STATE OF NORTH CAROLINA
DEPARTMENT OF TRANSPORTATION

May 1, 2020

Subject: Revised Modification Request for the Section 404 Individual Permit and Section 401 Water Quality Certification for the proposed Havelock Bypass in Craven County. TIP No. R-1015. Debit \$ 570 from WBS 34360.1.2

**PERMIT DRAWING
SHEET 28 OF 167**

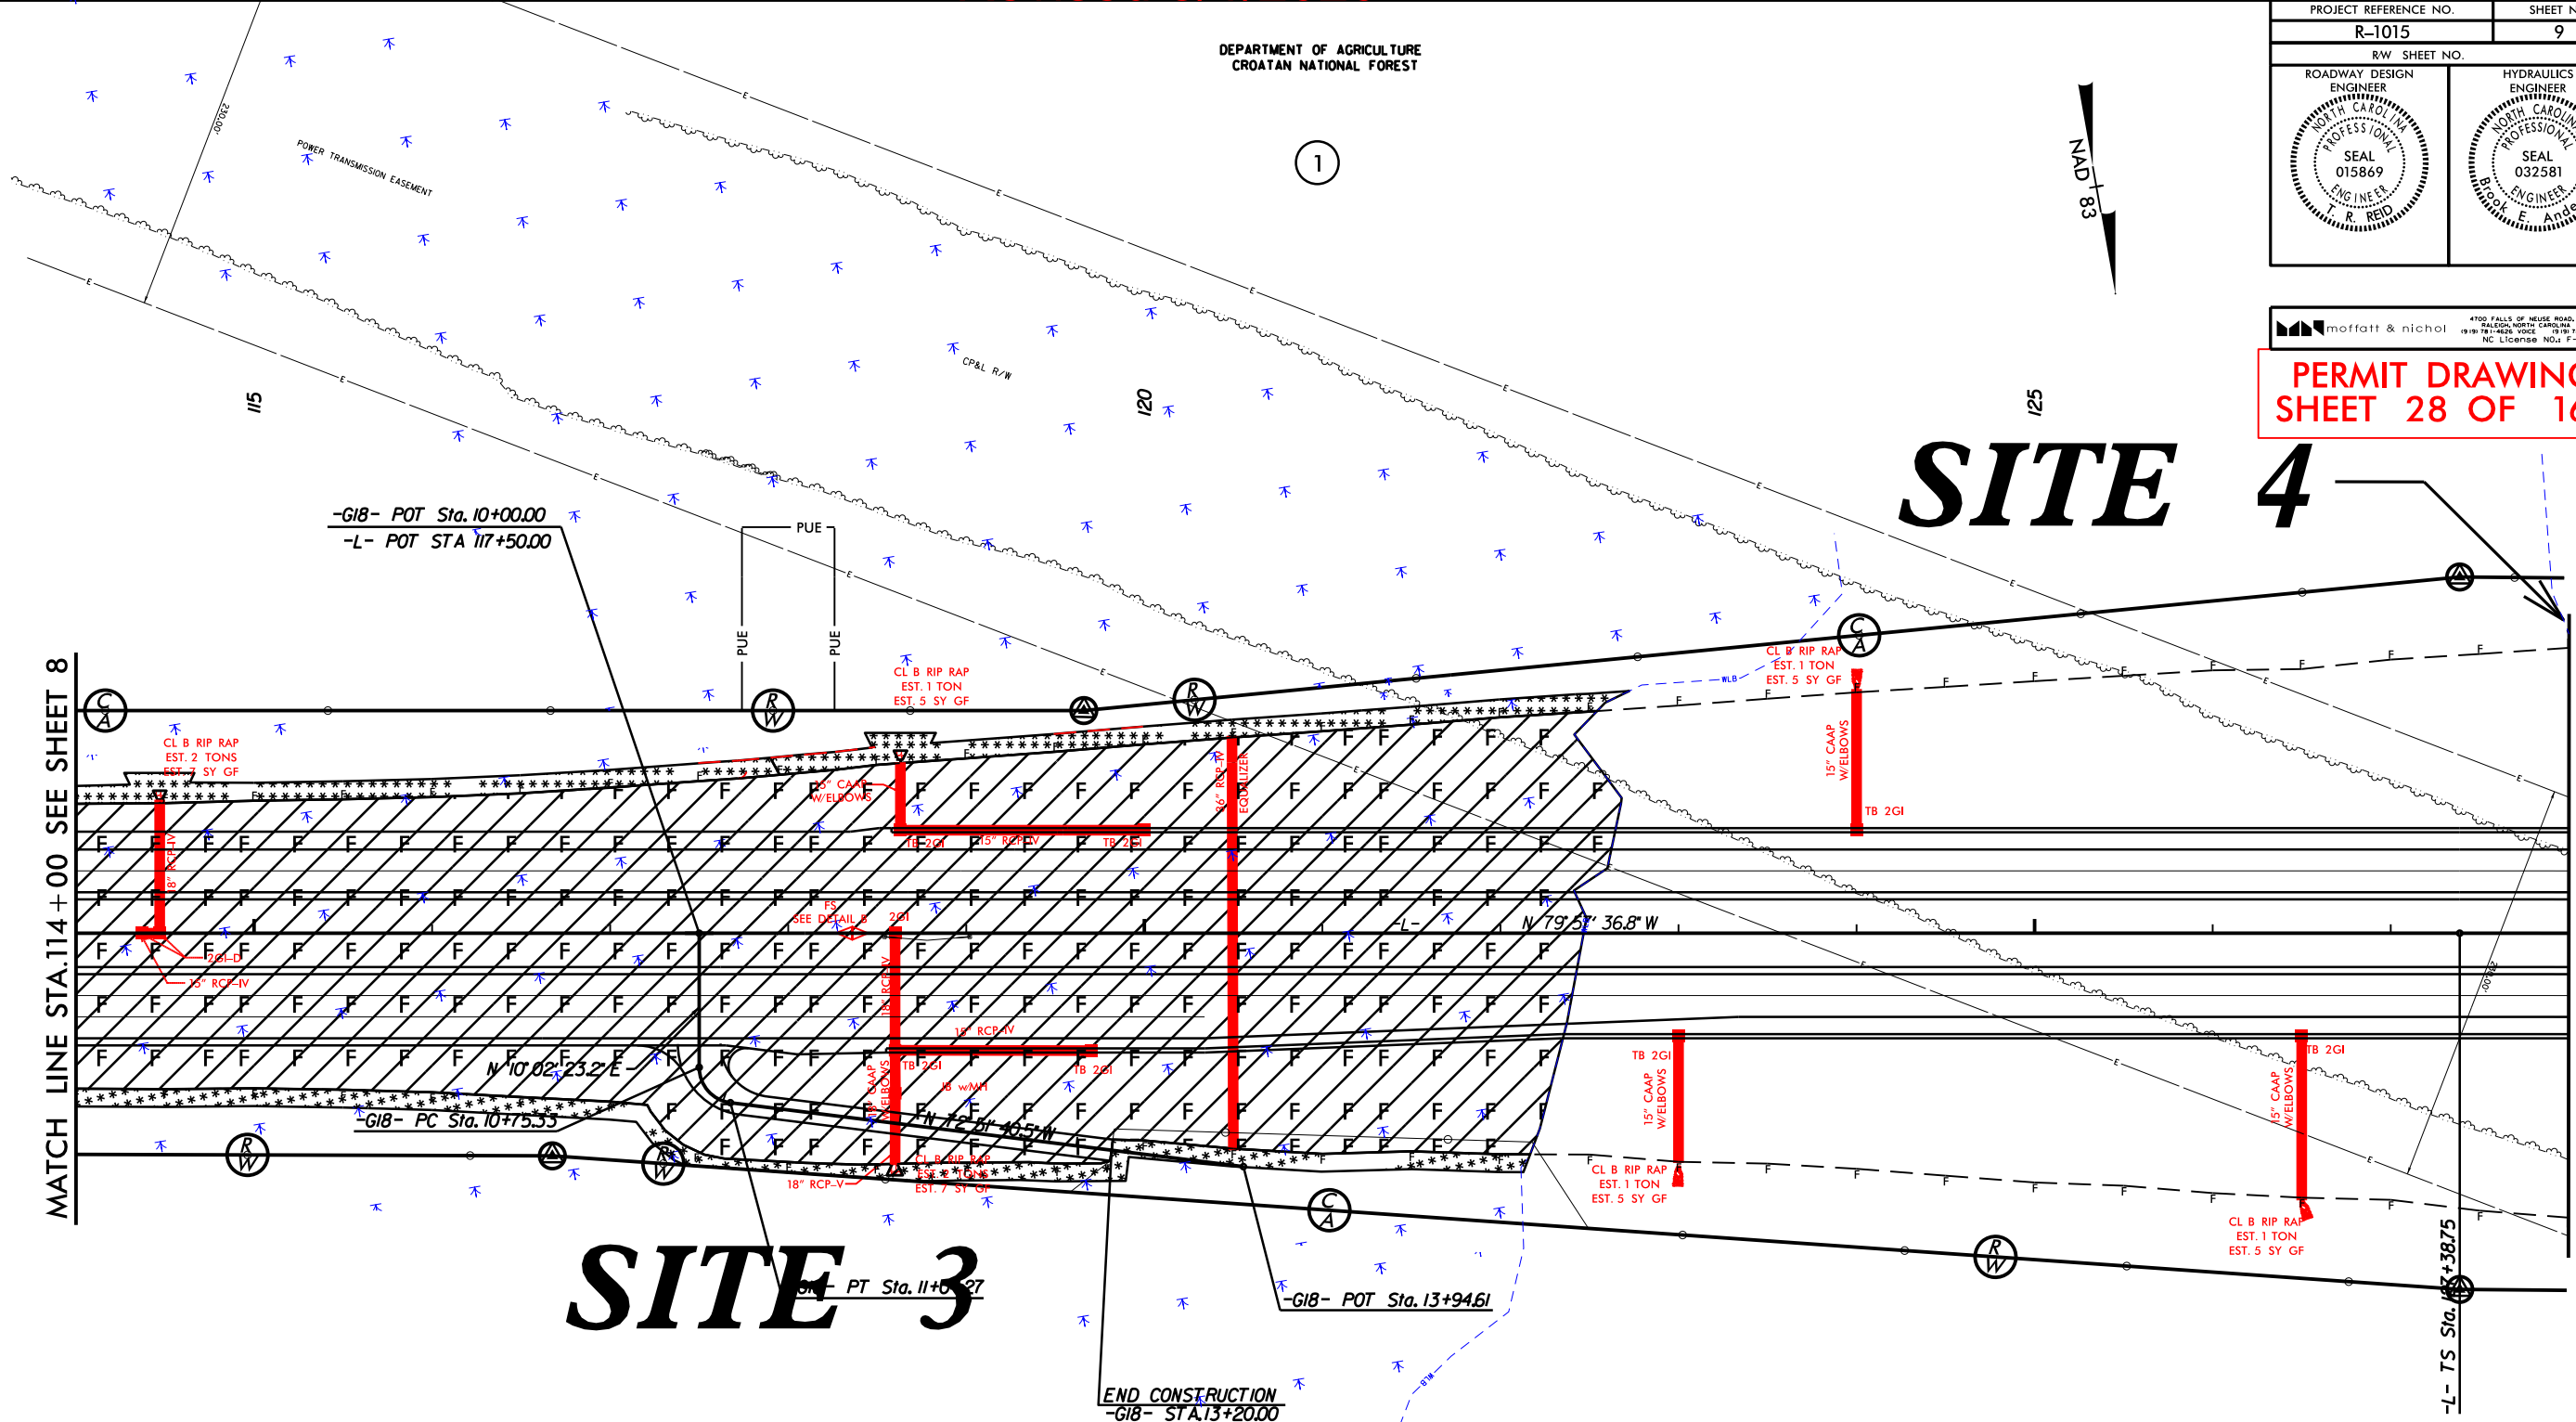
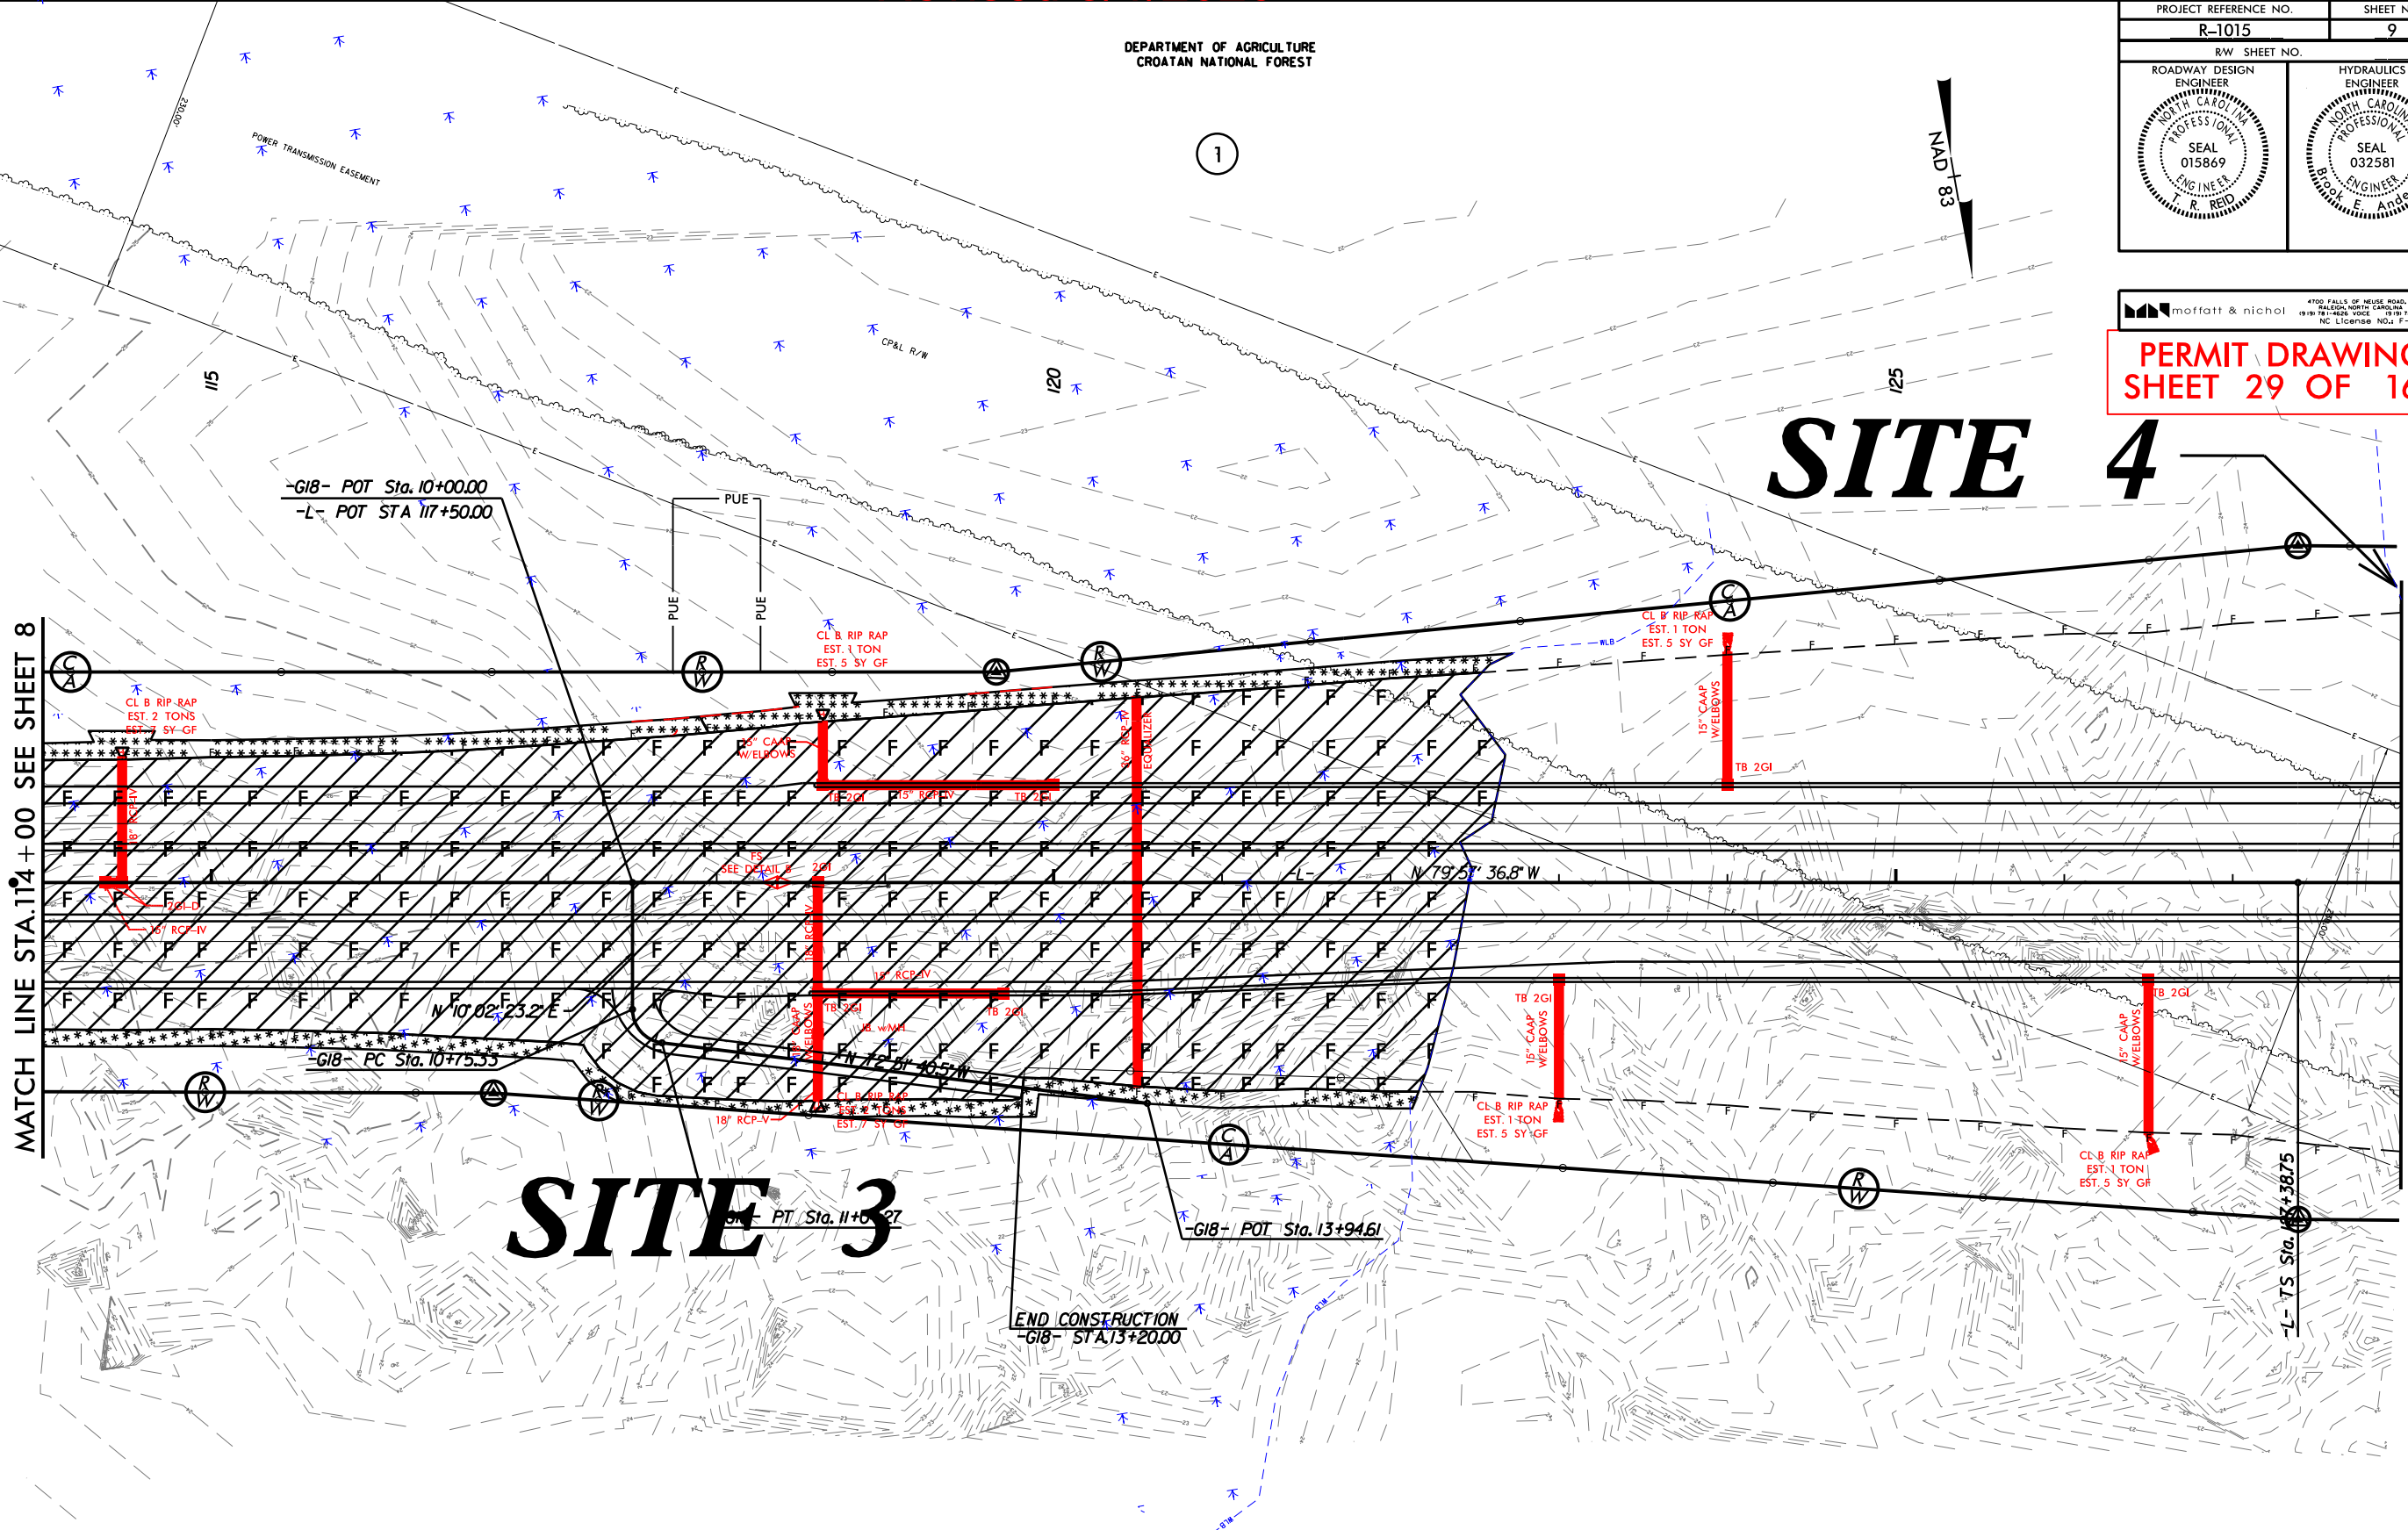
- **Site 3: (permit sheets 28 & 29) a driveway was relocated and an error found in the original permit total from 4/9/2019. Fill increases by 0.12 acre. Mechanized Clearing decreased by 0.03 acre. Total difference a 0.09 increase in permanent impacts.**

- Actual new Fill Impacts = 26.034 acre, Total old Fill impacts=25.906 acre; actual difference 0.128 acre, rounded difference (26.03-25.91) = 0.12 acre as reported
